# City of Santa Fe, New Mexico

**Project number:** 09-10100090

**Case number:** H-09-090

**PROJECT LOCATION (S):** 519 E. Palace Ave

PROPOSED AMENDMENT TO NORTH ELEVATION

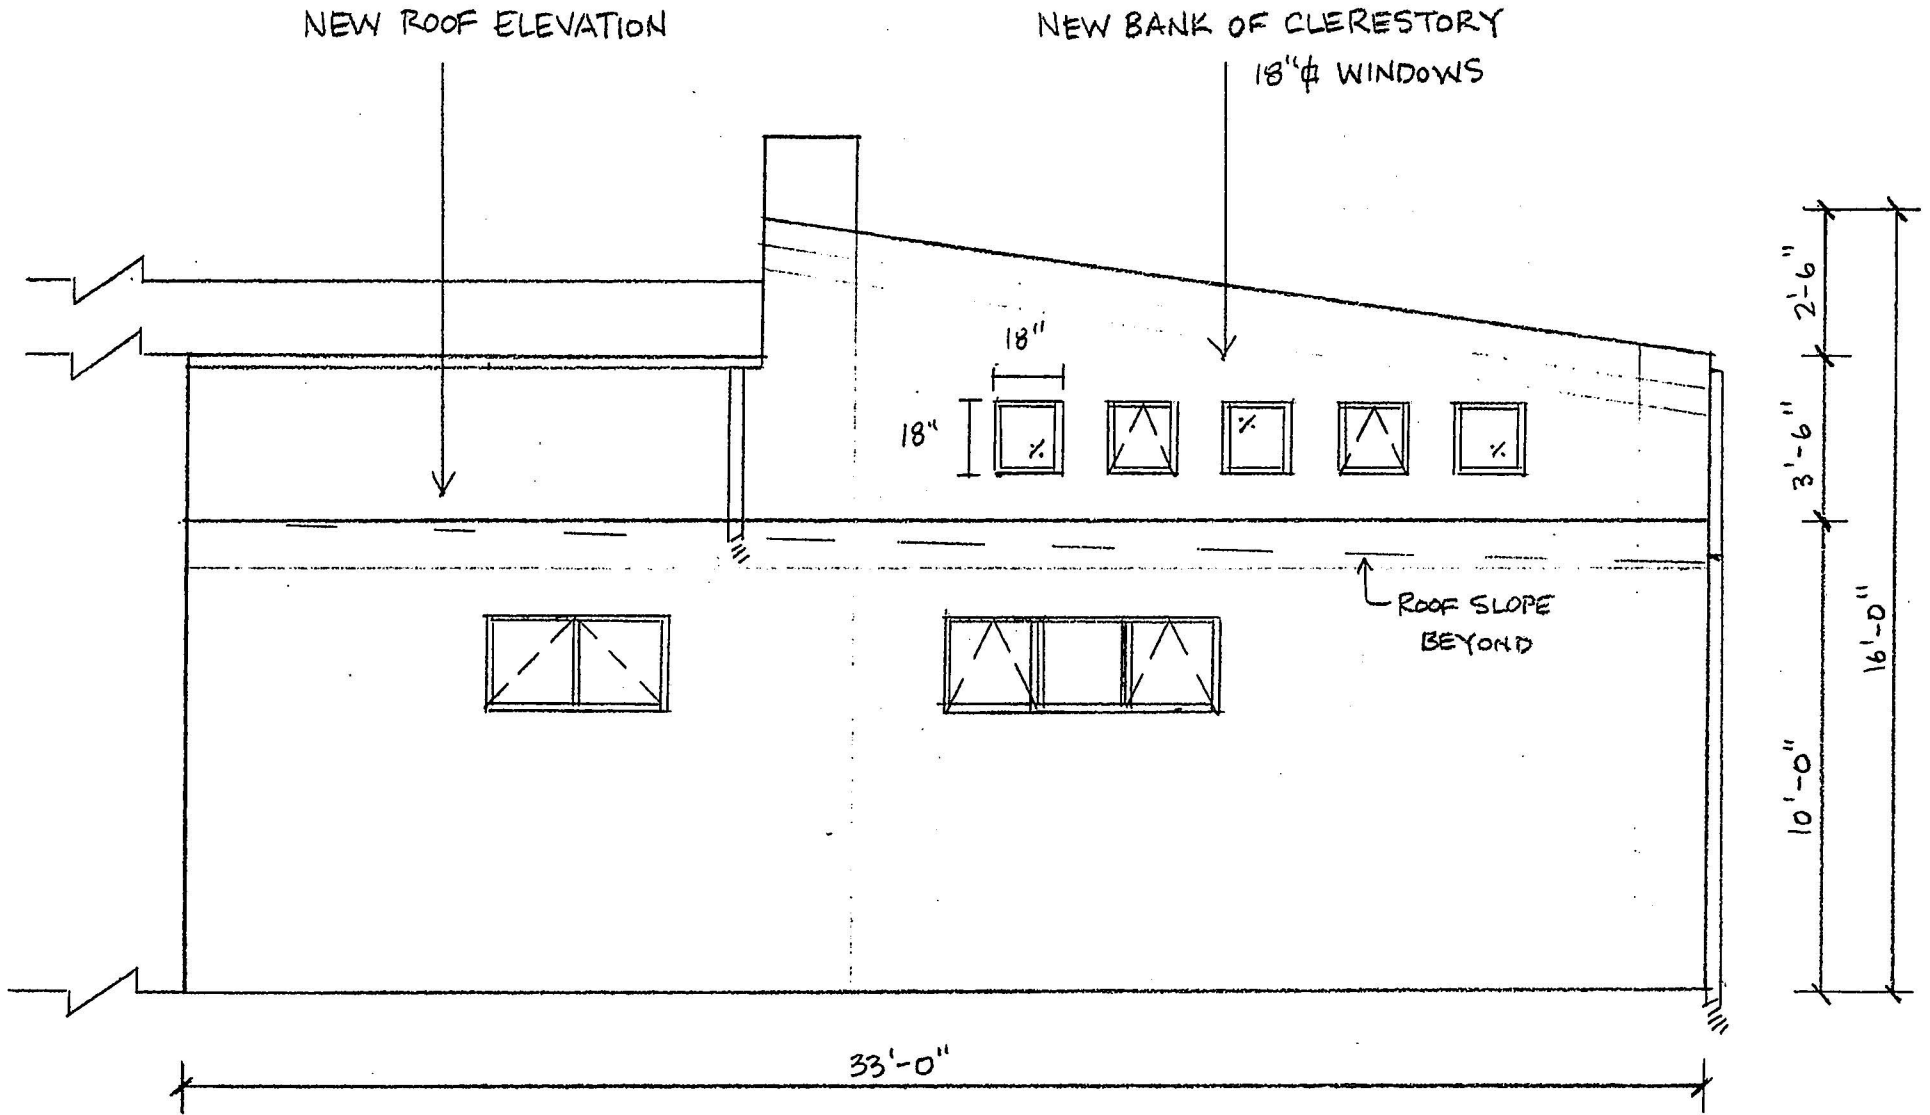
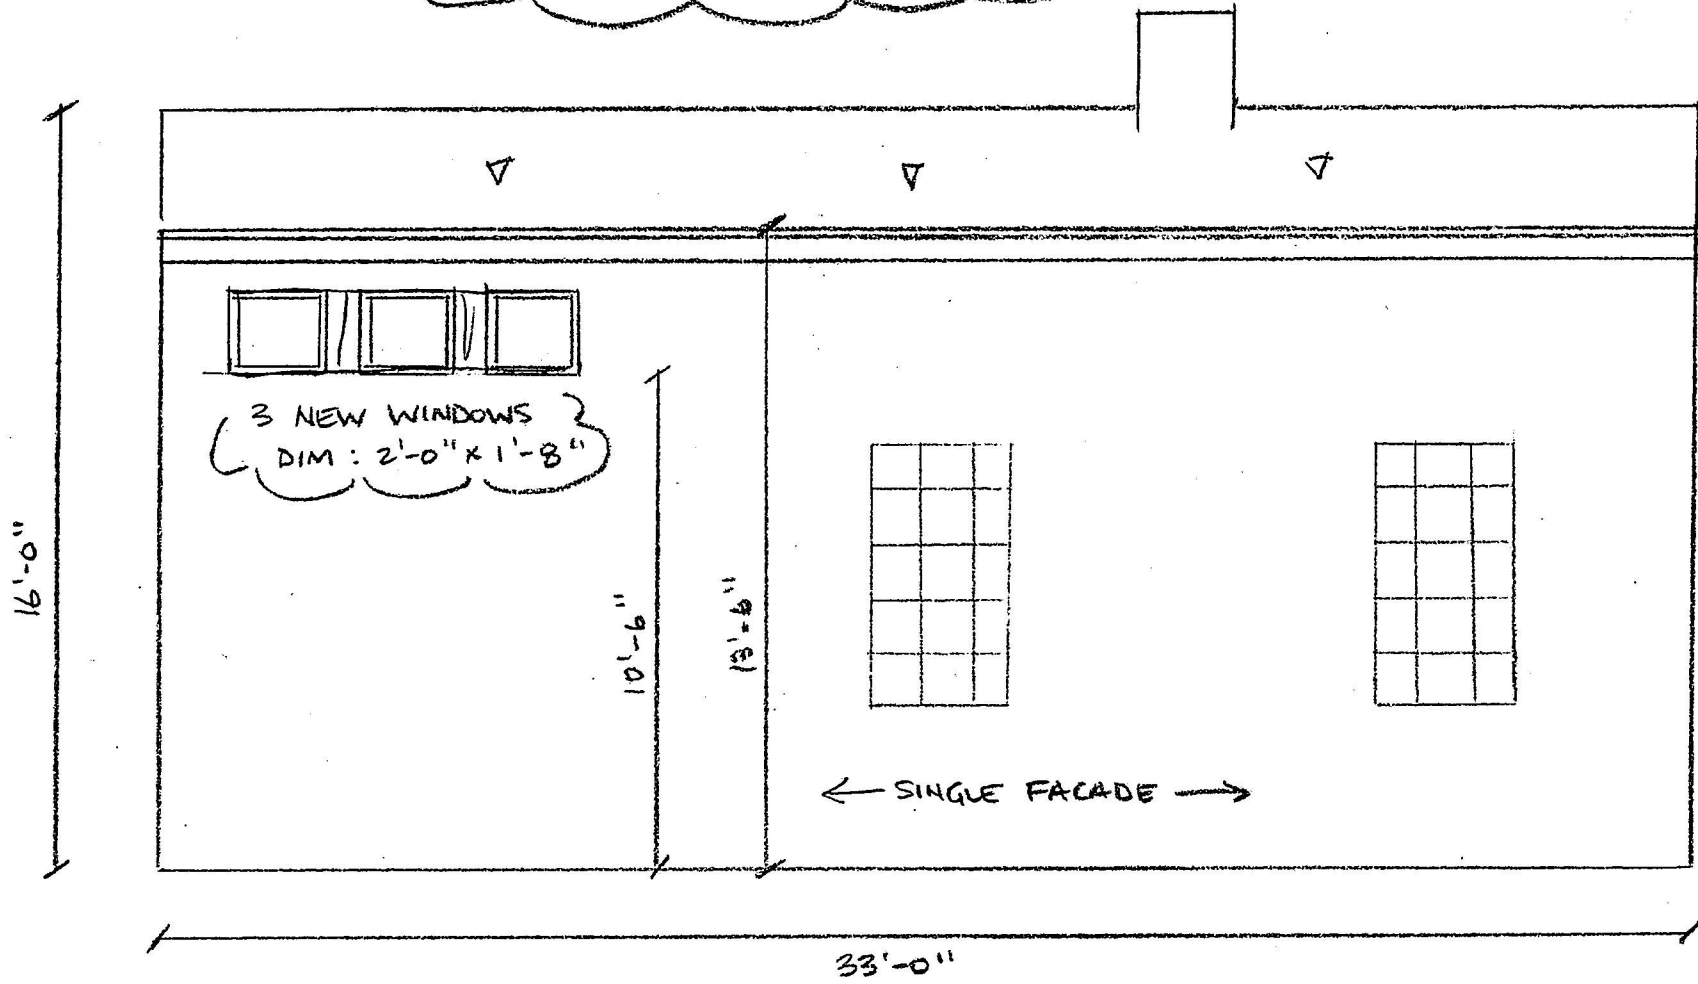
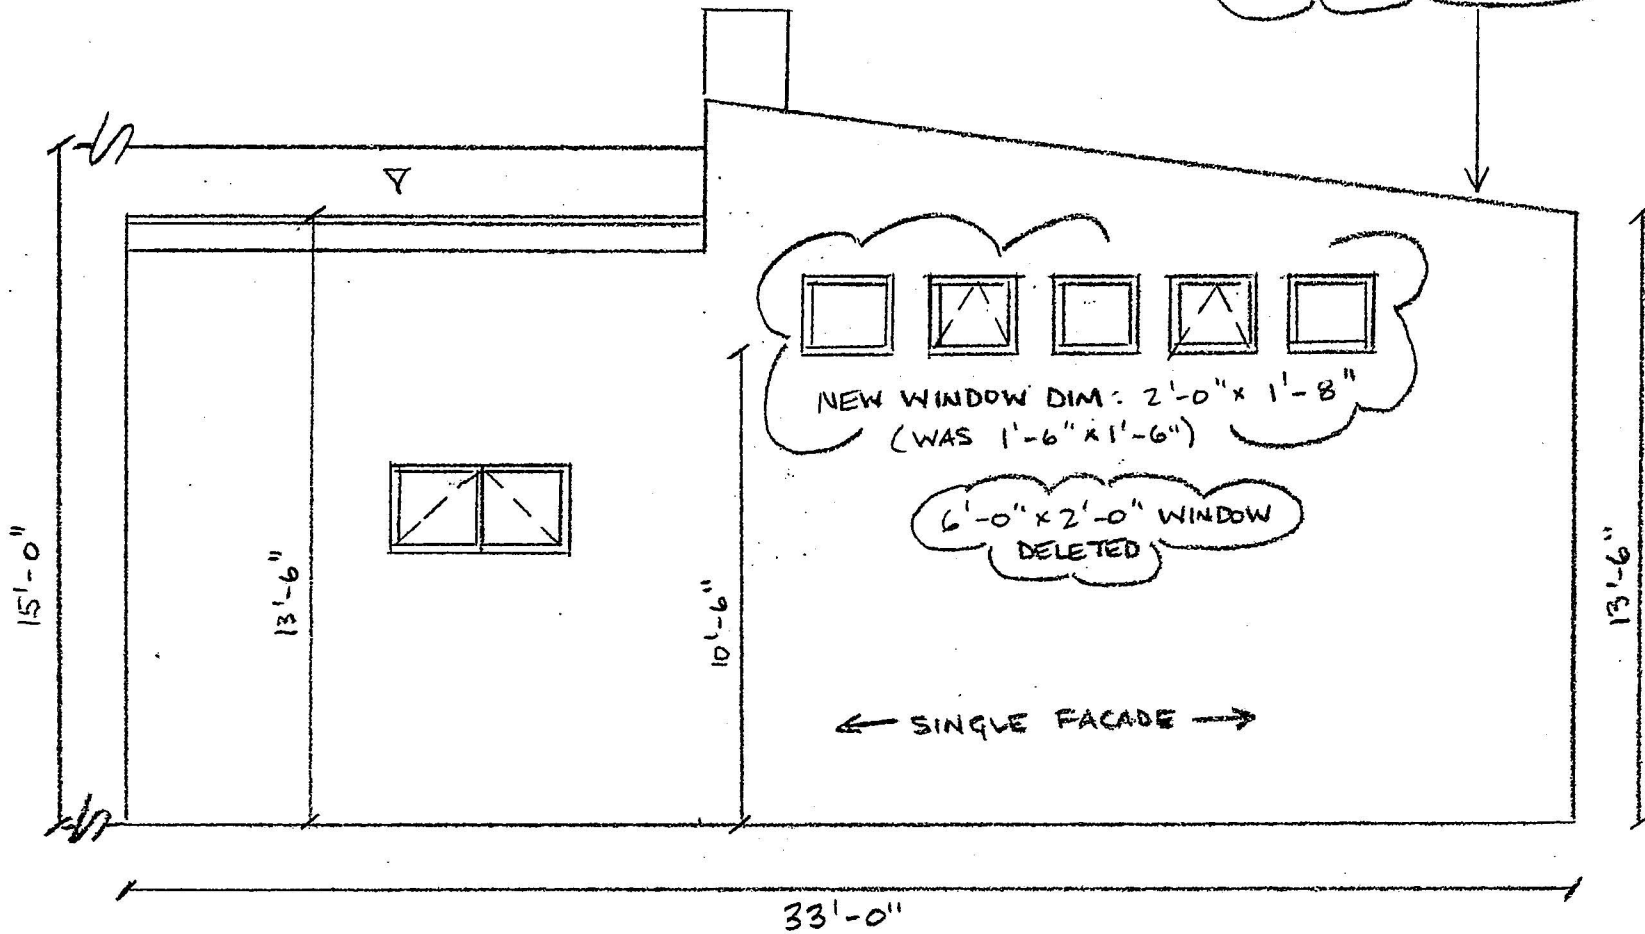
we wanted to run something by you -- we recently had a surveyor out and discovered that the carport steel posts on the north side are directly in front of our north master bathroom window.

In order to avoid the obstructing posts, we have to delete the north master bathroom window (6'x2'). But, in order to get some natural light into the master bathroom, we would like to go back to having only one northern facade where the 5 clerestory windows will be relocated. Thus, no drop-down roof needed over the master bathroom.

1. Could making the described change be administrative or would it trigger going back to the H-board?
2. If we want to add 3 new clerestory windows to the west elevation (approx. same overall dimension as deleted window), could this be administrative as well?

I should point out that the original clerestory window dimensions are slightly increased, so that we may order a standard size rather than a custom sized window (big price difference). AND, yes, we still satisfy the 30 inch requirement!

BACK TO ORIGINAL:  
ONE WESTERN FACADE ELEVATION /  
ONE ROOF (GUMBY) ELEVATION

BACK TO ORIGINAL:  
ONE NORTHERN  
ELEVATION /  
ONE ROOF ELEVATION

PROPOSED NORTH ELEVATION SCALE 1/4" = 1'

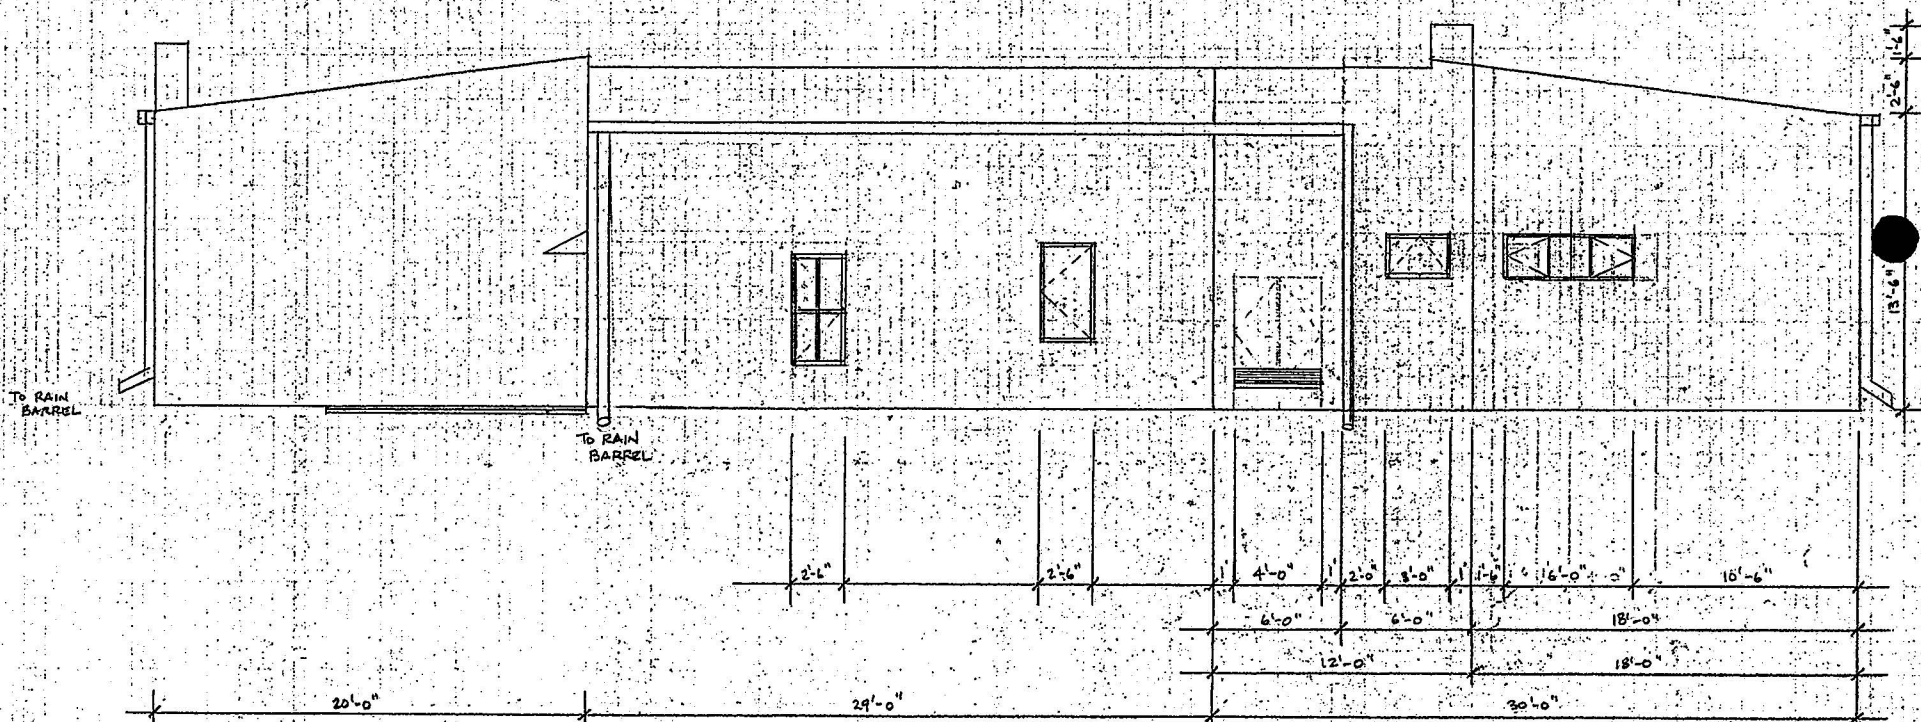
Staff recommends approval of this application with the condition that the two non-compliant windows on the rear elevation meet the 30" rule. Otherwise, this application complies with Section 14-5.2 (C) Regulation of Contributing Structures, (D) General Design Standards, and (E) Downtown & Eastside Historic District.

3. Two windows on the non-primary, north elevation will be replaced. The historic 2-over-2 window from the west elevation remodel will be reused, if possible. The window on the non-visible north elevation in the guest room does not meet the 30" rule.
